UNITED STATES PATENT AND TRADEMARK OFFICE

APPLICATION NO.	FILING DATE	FIRST NAMED INVENTOR	ATTORNEY DOCKET NO.	CONFIRMATION NO.
09/552,576	04/19/2000	William J. Oswald	9840-041-999	3976

# Office Action Summary

FIGURE 2

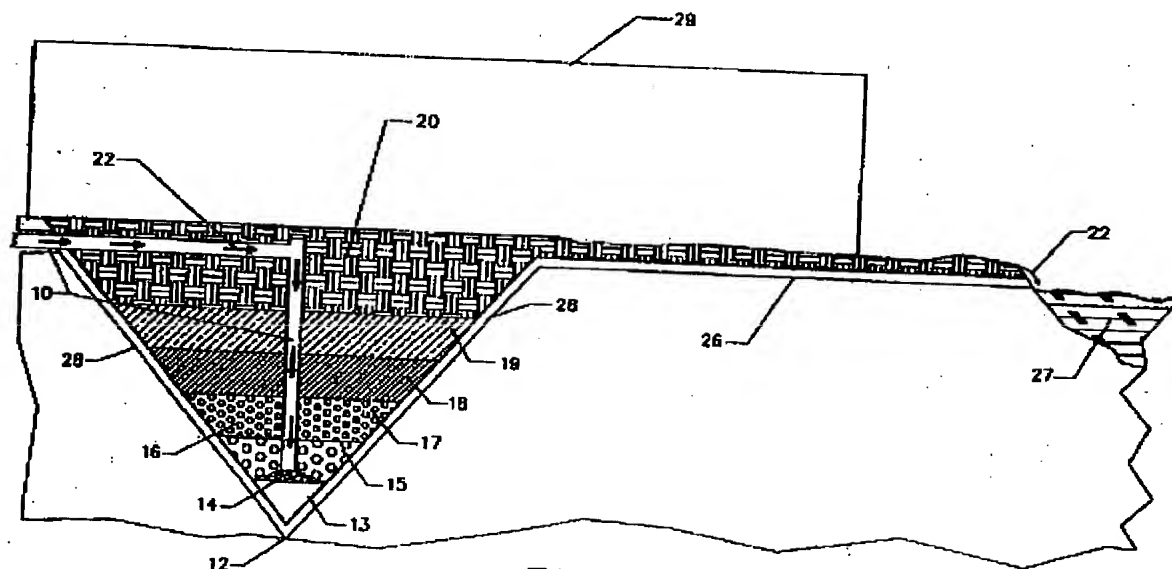
Vandervelde '568 at Fig. 2 describes a structure comprising an outer pond (defined by sand layer 20) larger in area and overlaying an anaerobic inner pond (layers 13 – 19). The skilled artisan would have understood that methane fermentation necessarily takes place at least at layer 13. Wastewater is fed through pipe 10 to the apex of the structure at the bottom of the anaerobic methane fermentation pit. Housing 29 is optional. The pond is "substantially open" insofar as the surface of the liquid contained by the outer pond is exposed to ambient air and light.

FIG. 8

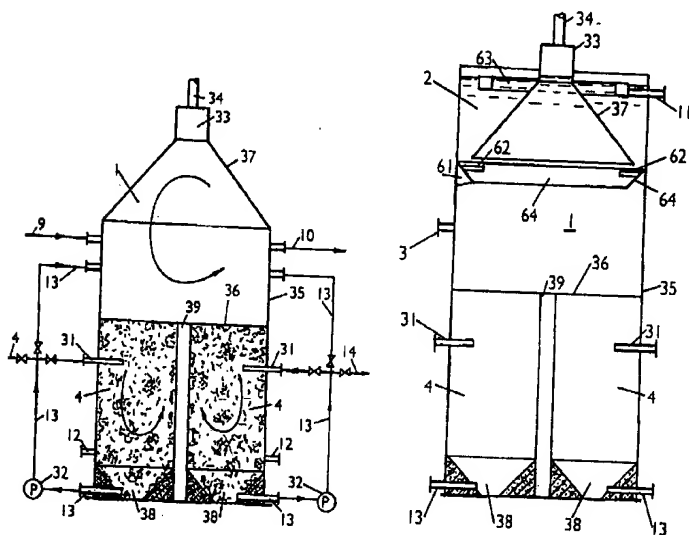
Claims 2, 15, 26 are rejected under 35 U.S.C. Sec. 102(b) as anticipated by USP 5616241 to Khudenko. Khudenko describes a pond (fig 8 or fig. 14) having a lower anaerobic methanogenic zone and an upper zone overlying the methanogenic zone. The pond is a vessel having a substantially open surface because methane and other gases can escape therefrom via submerged gas collector 37 (fig 14) and gas bell (conduit) 33, 34.
